CONSERVATION TEAM CONSULTATION APPLICATION RESPONSE

APPLICATION REF:	25/03103/FPH & 25/03104/LBC
CASE OFFICER:	HS
APPLICATION SITE:	Hexton Manor, Hexton, Hitchin, Hertfordshire, SG5 3JH
DESCRIPTION OF WORKS:	Conversion of gardener's store to security guard office including external alterations. Internal and external alterations to facilitate conversion of gardener's store to security guard office.

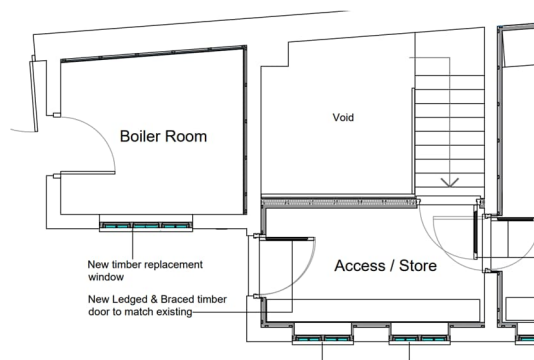
In my opinion, the alterations to the window opening below i.e. making this deeper so that the new window sits directly on the sill, is considered acceptable. The only issue is to ensure that the slimlite glazing incorporates 'through' as opposed to 'applied' bars.

Through bars will increase the cost of each window and with this in mind I raise no objection to these being changed to 6-pane should the applicant wish to do so.
